**S.16 Planning Application No. A/YL-KTS/910**
**Proposed Religious Institution (Mosque) within "Agriculture" ("AGR") Zone on the Approved Kam Tin South Outline Zoning Plan No. S/YL-KTS/15, at Lot 1542 RP (Part) in D.D. 106, Yuen Kong San Tsuen, Kam Tin, Yuen Long**
**Further Information**

**Section 16 Planning Application under the Town Planning Ordinance**
**Proposed Religious Institution (Mosque)**
**Lot 1542 RP (Part) in D.D. 106, Yuen Kong San Tsuen, Pat Heung, Yuen Long**

**Re: Section 16 Planning Application for Proposed Religious Institution (Mosque) at Lot 1542 RP (Part) in D.D. 106, Yuen Kong San Tsuen, Pat Heung, Yuen Long (Planning Application No. A/YL-KTS/910)**

**Planning Application No. A/YL-KTS/910**

**Figure 3.1 Swept Path of Private Car (IN Movement)**

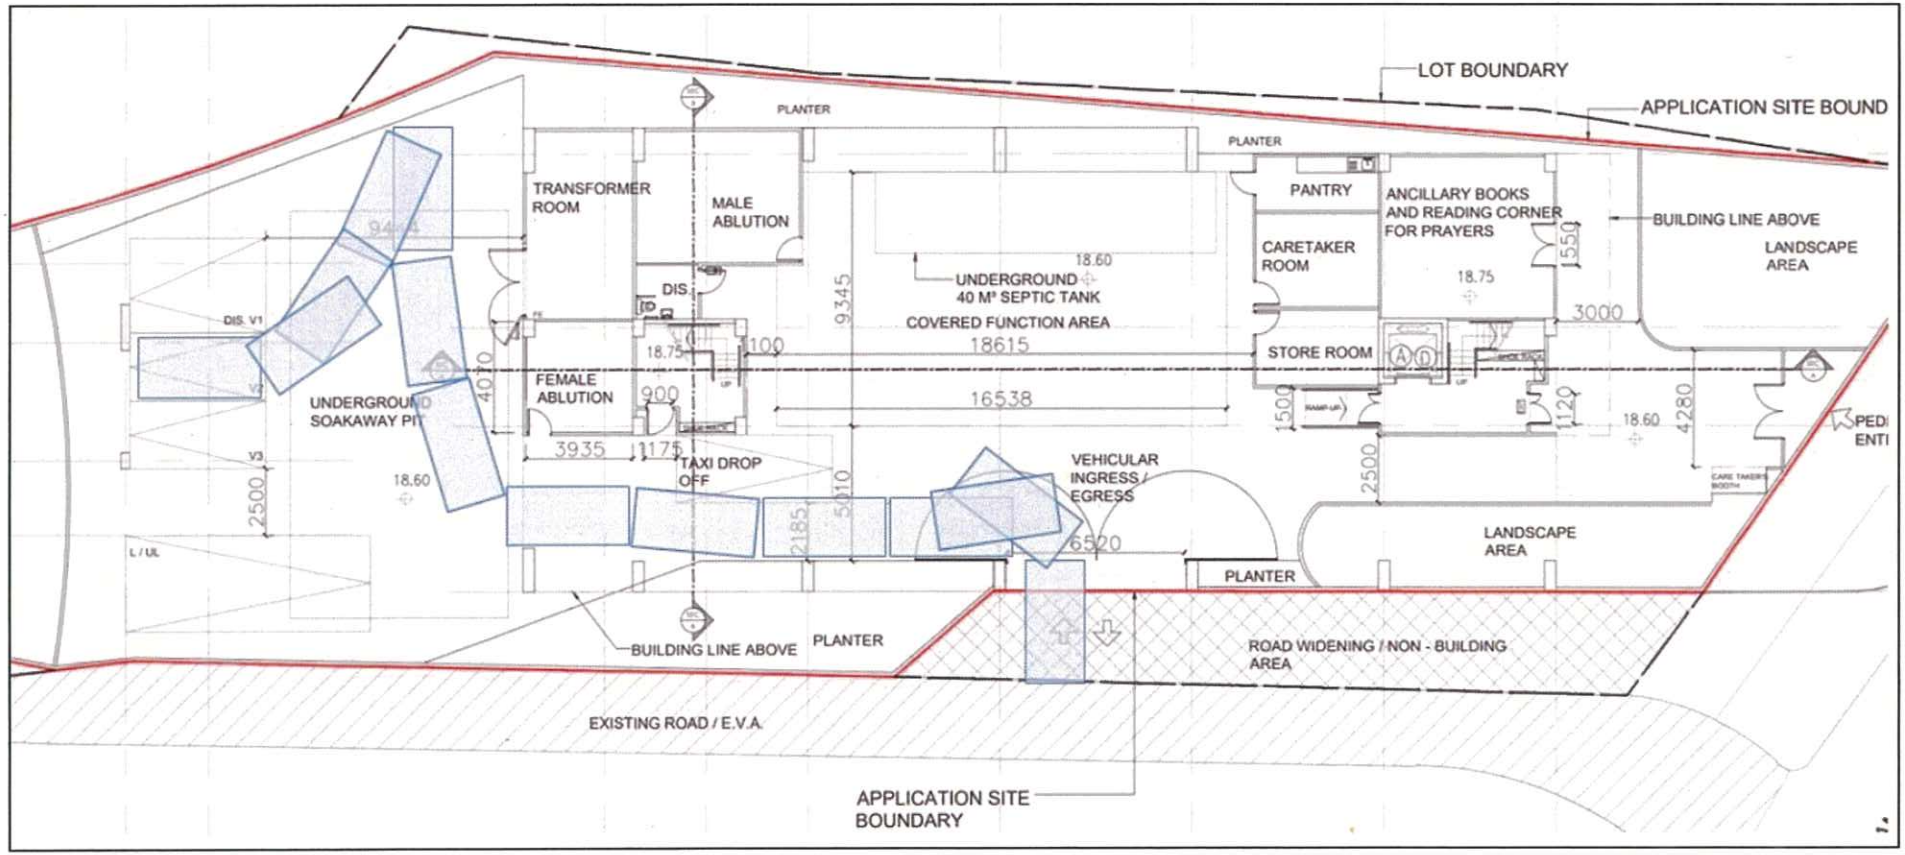
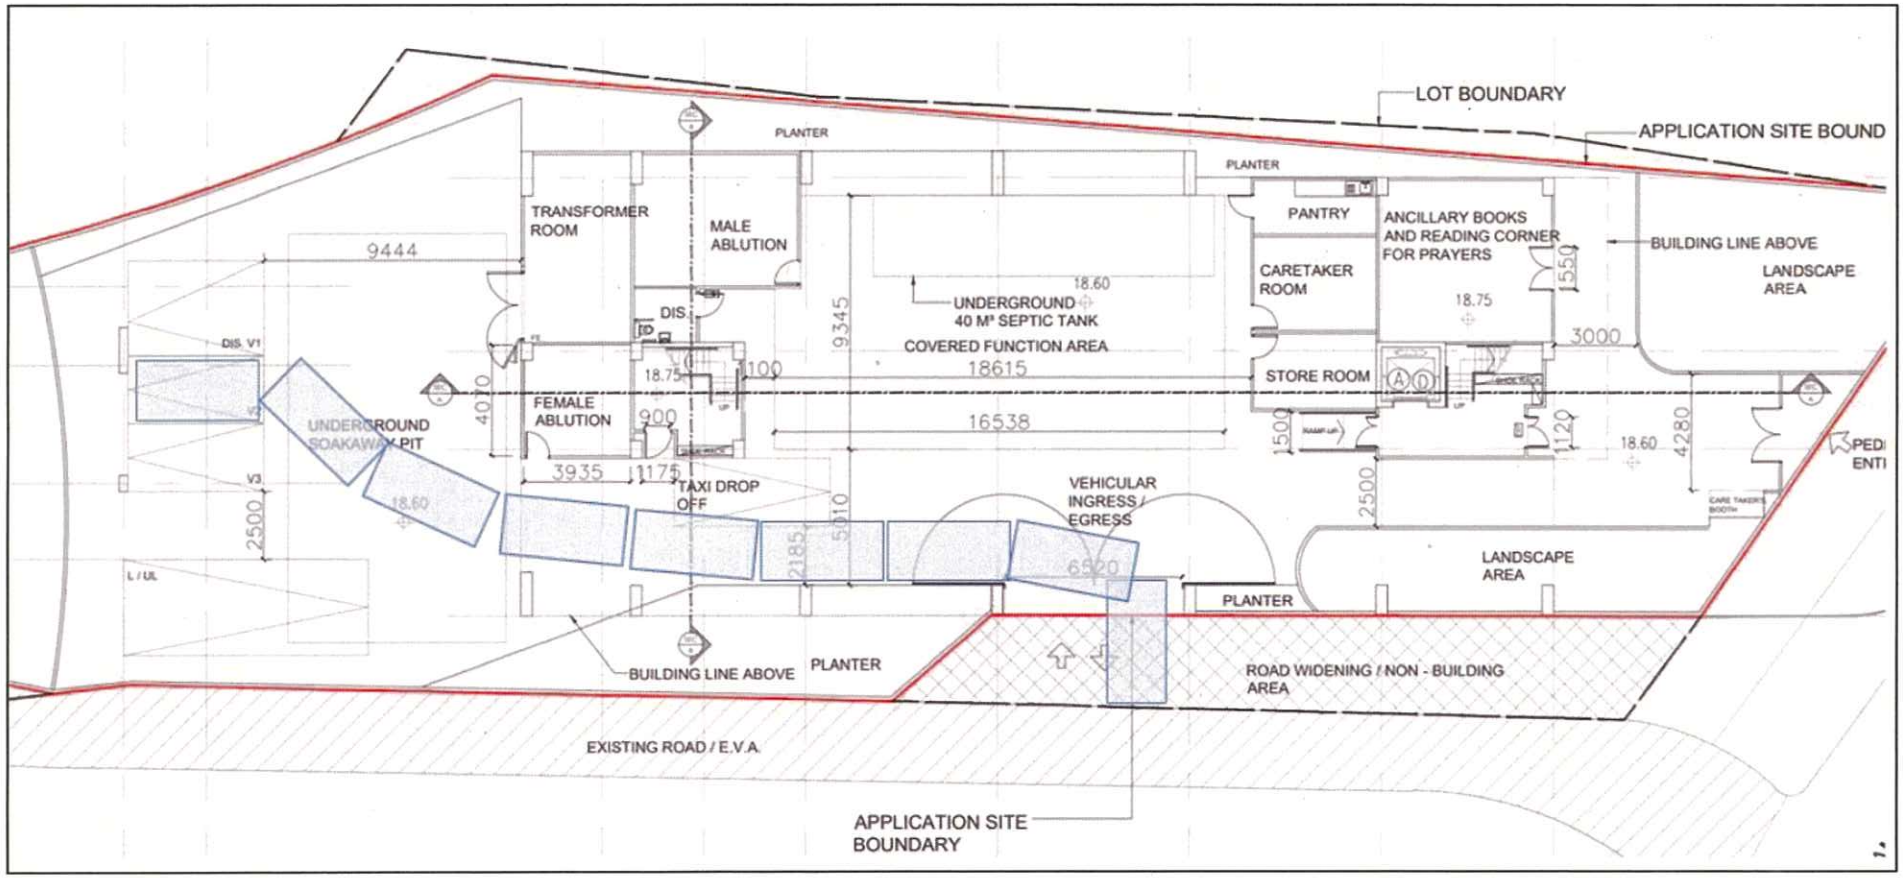
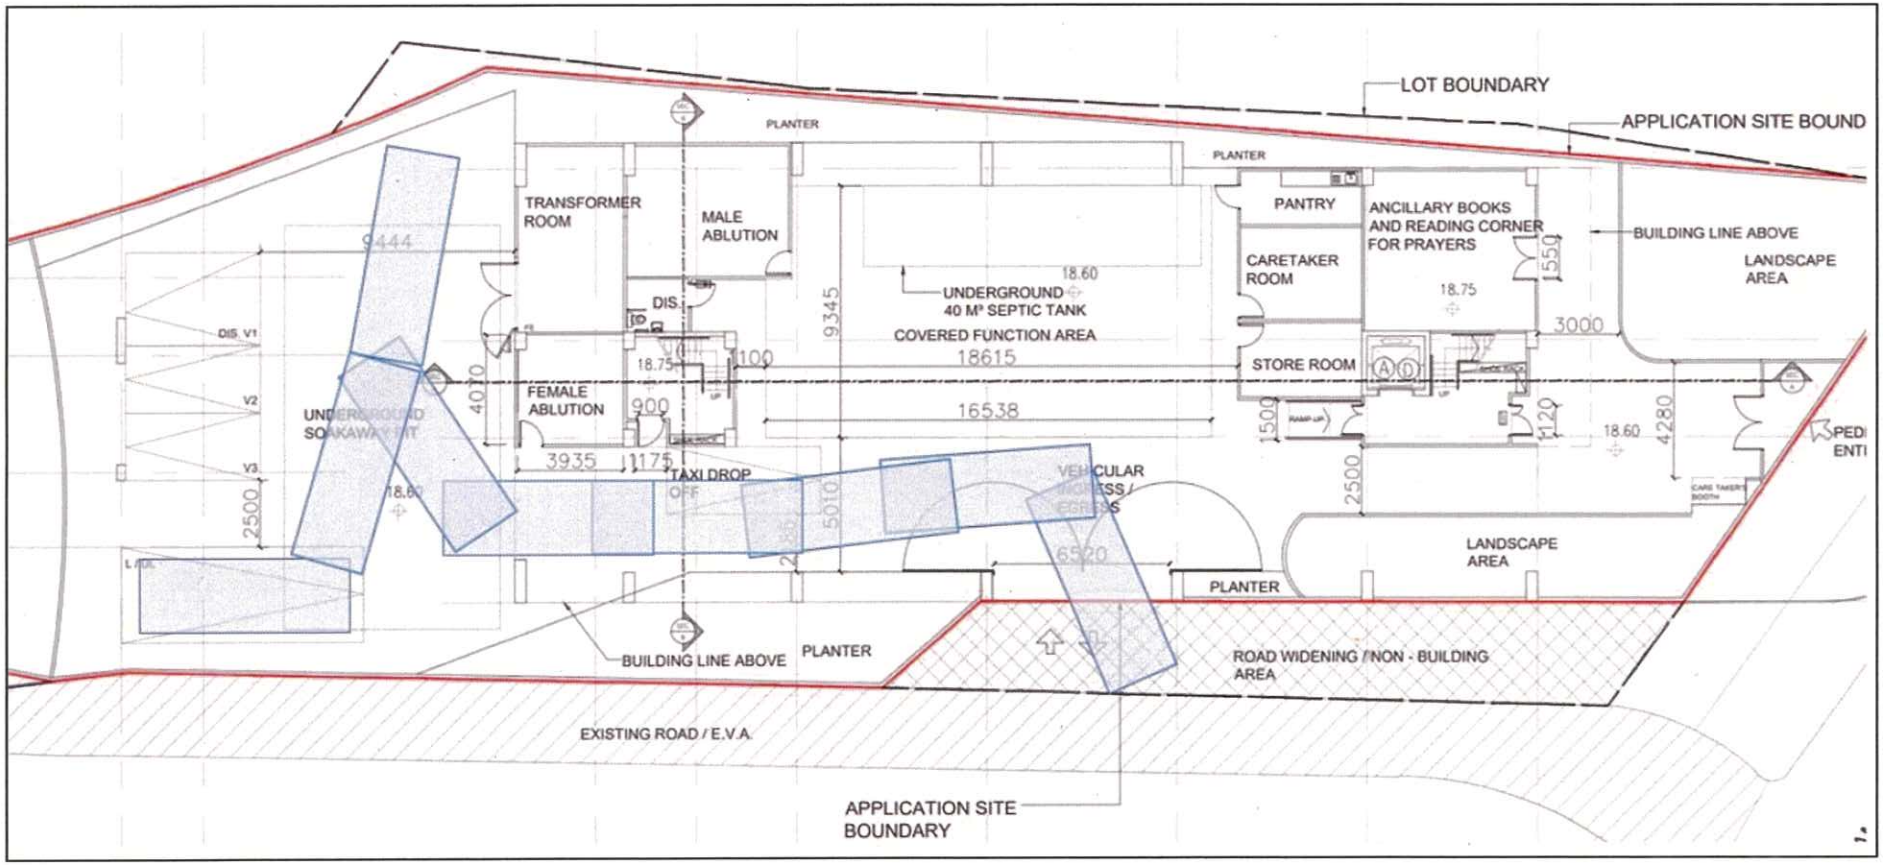
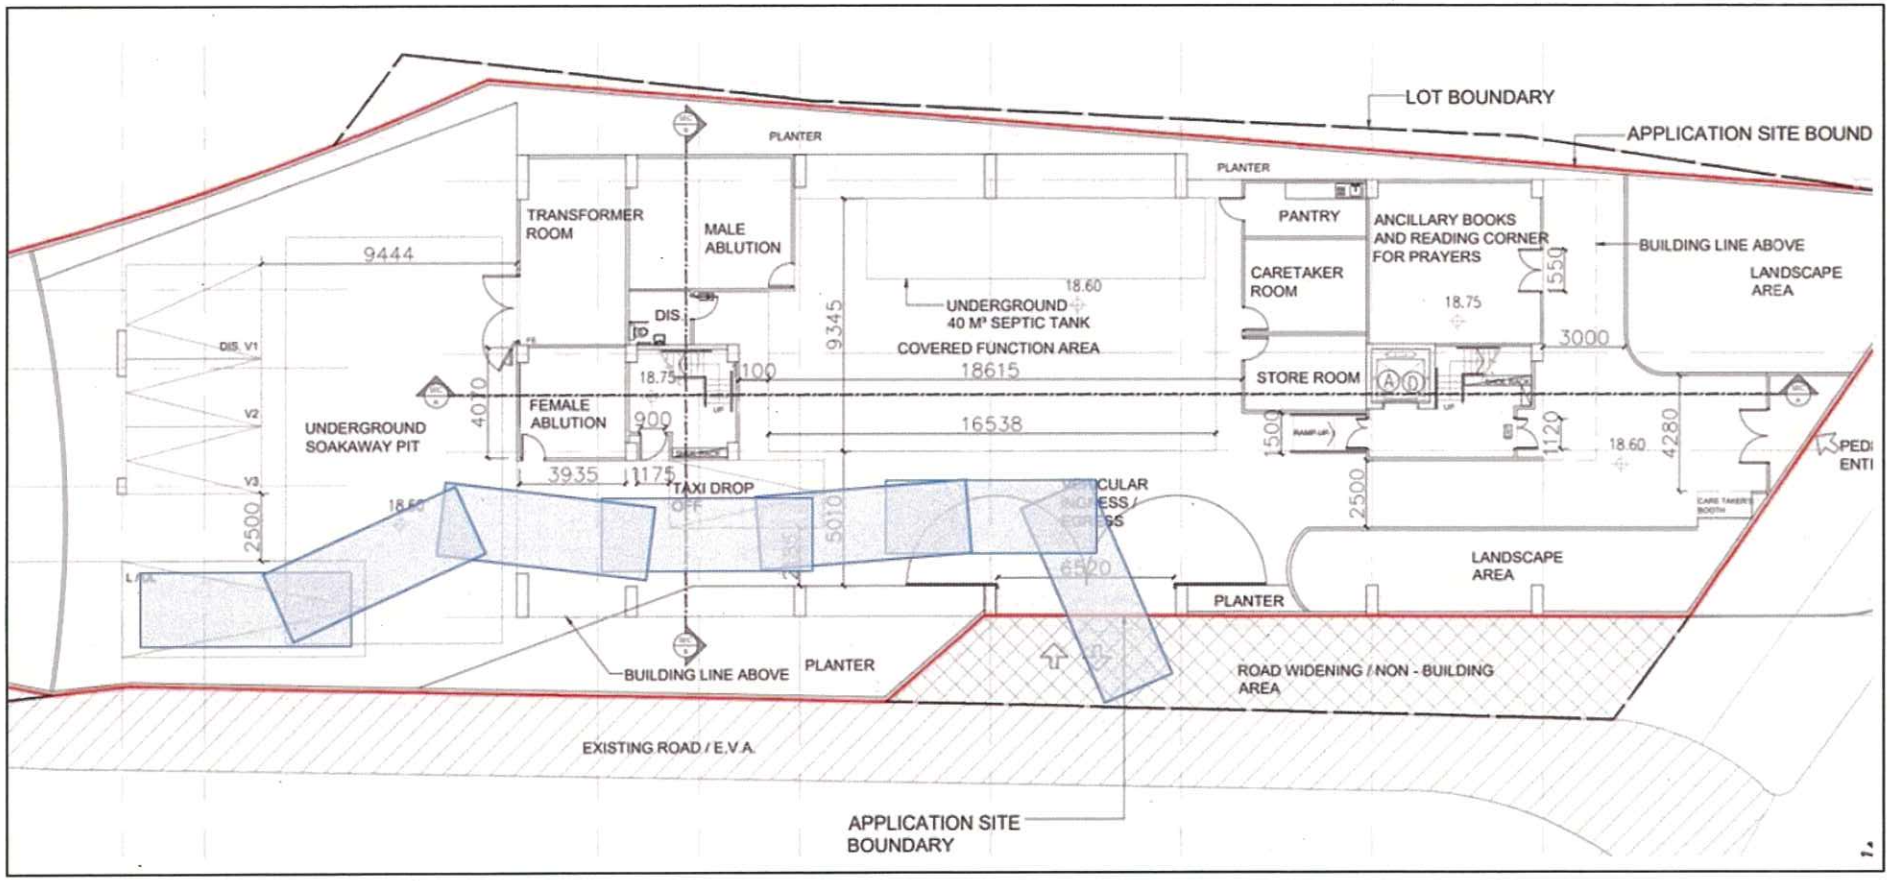
| Comments from TD | Responses by the Applicant |
|---|---|
| (a) Please clarify the intended use for the 3 parking spaces (whether these are used for staff or visitors etc.) and elaborate the loading / unloading operation to justify the proposed parking provisions. | The mosque goers are local people or residents in Kam Tin and the Site is abutting Kam Sheung Road where there are various public transport means including buses and minibuses. As such, they will visit the Site either on foot or by public transport. Bus routes No. 64K, 64S, 251A and E36P run along Kam Sheung Road and the nearest bus stop is located one-minute walking distance from the Site, as indicated on the following plan (**Figure 3.7**).<br><br>Only 3 carparking spaces plus a taxi drop-off and a loading/unloading space are proposed in the current application. Significant traffic trips arising from the proposed mosque are therefore not expected and hence insignificant impact on the surrounding road network.<br><br>The 3 parking spaces are only reserved for VIPs and the Chairman of the Amsua Education Foundation. As mentioned in the submitted planning statement, VIPs would include consulates from various Muslim countries, e.g. Pakistan, Indonesia, Qatar and Saudi Arabia. |

**Figure 3.5 Swept Path of Taxi Drop-off (IN Movement)**

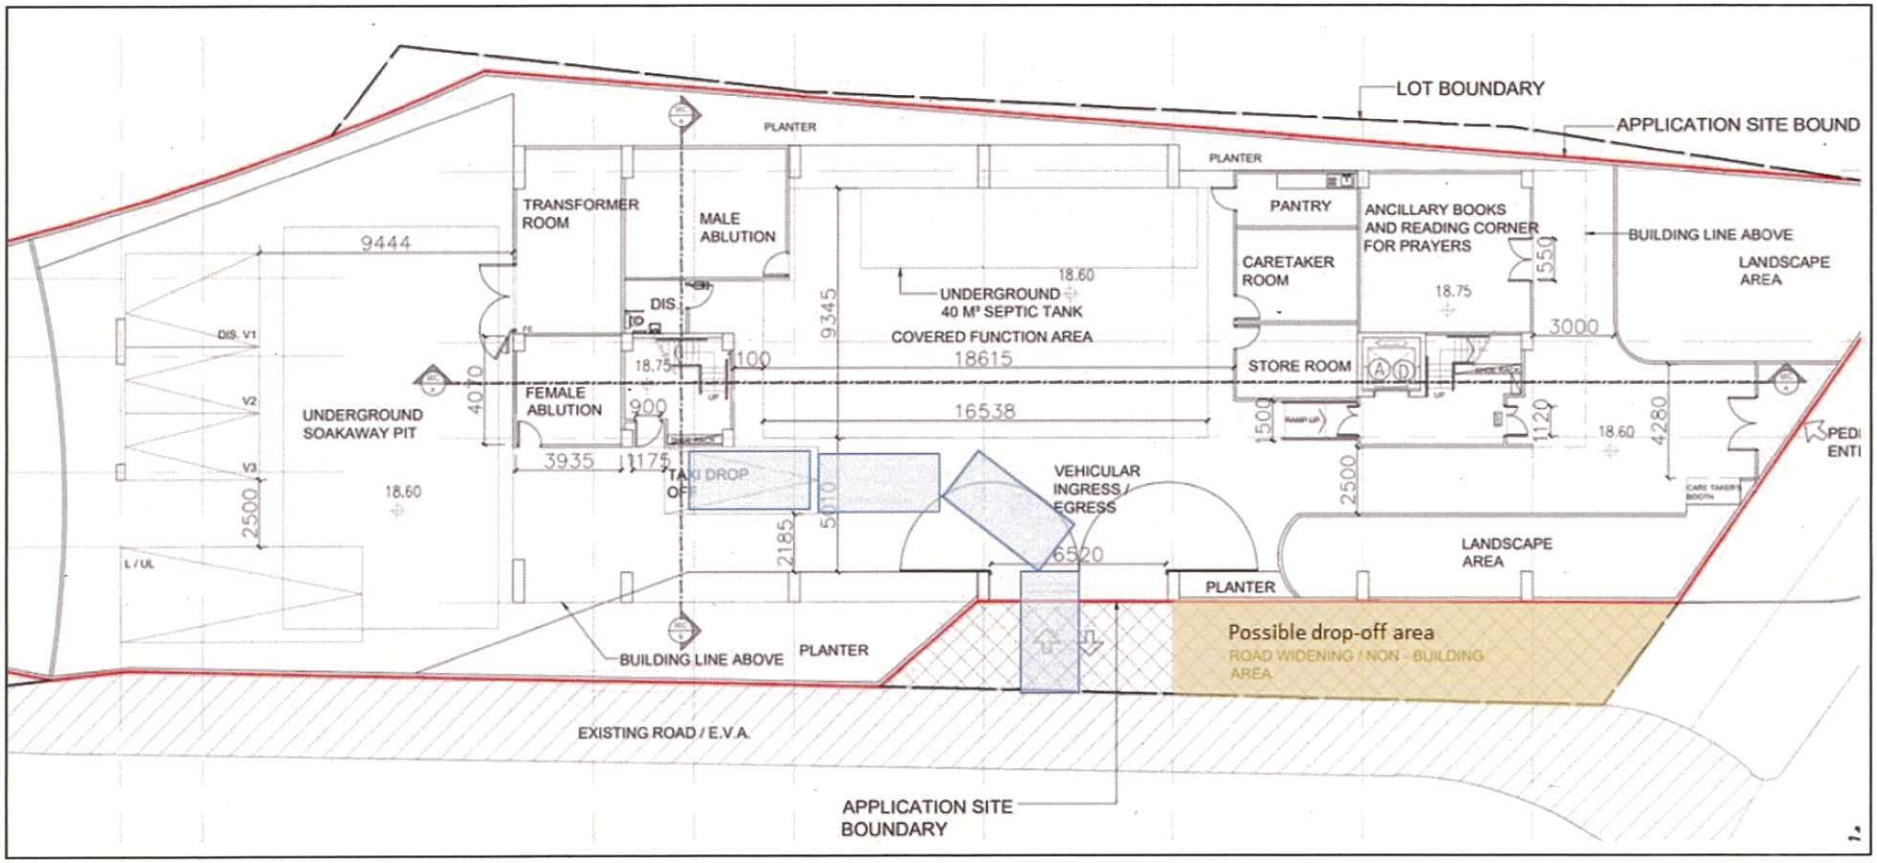
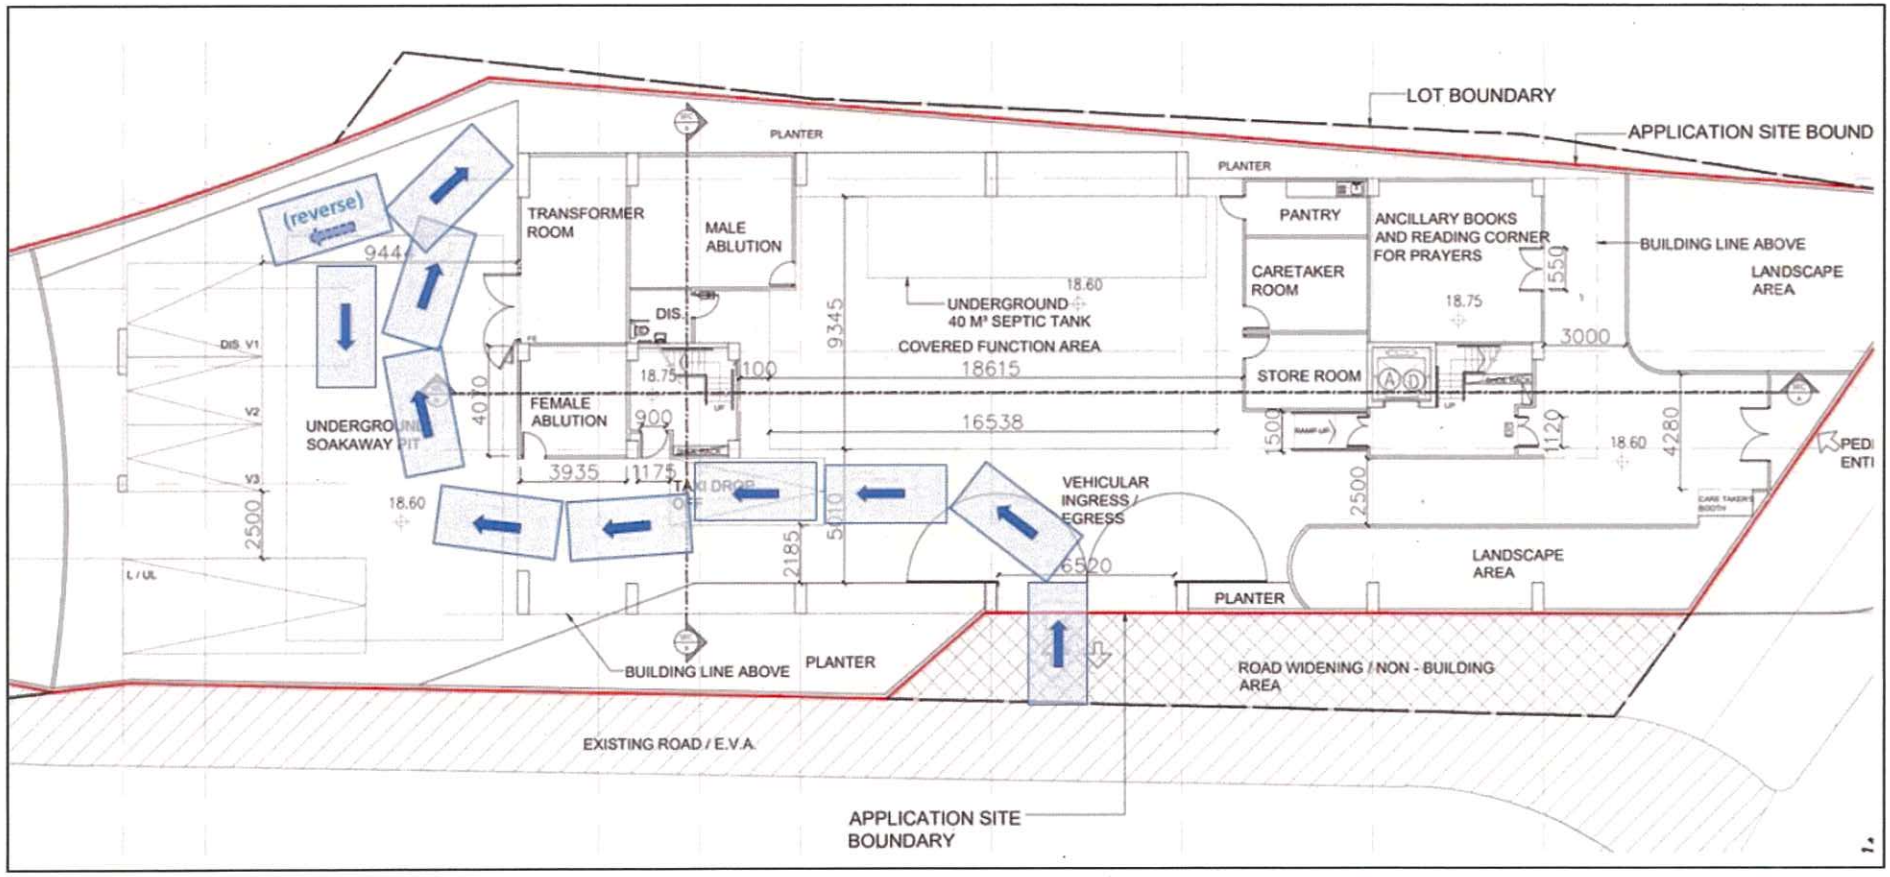
| Comments from TD | Responses by the Applicant |
|---|---|
| (iii) Whether the taxi pick-up / drop-off, which requires vehicles to reverse, would be sufficient and efficient for the operation. | Please see below the indicative swept path for the taxi drop off (**Figures 3.5 and 3.6**) with sufficient maneuvering space within the Site. As also set out in the planning statement submitted to the TPB, the north-eastern boundary of the Site is proposed to be set back as non-building area (NBA) within the lot for widening of the local access road to improve the access arrangement, and demarcated for vehicular ingress/egress off Kam Sheung Road. This NBA as shown on **Figure 3.5** which is sufficient for dropping off passengers if needed.<br><br>The caretaker/staff of the mosque will monitor the situation and manage any traffic in/out of the Site. |
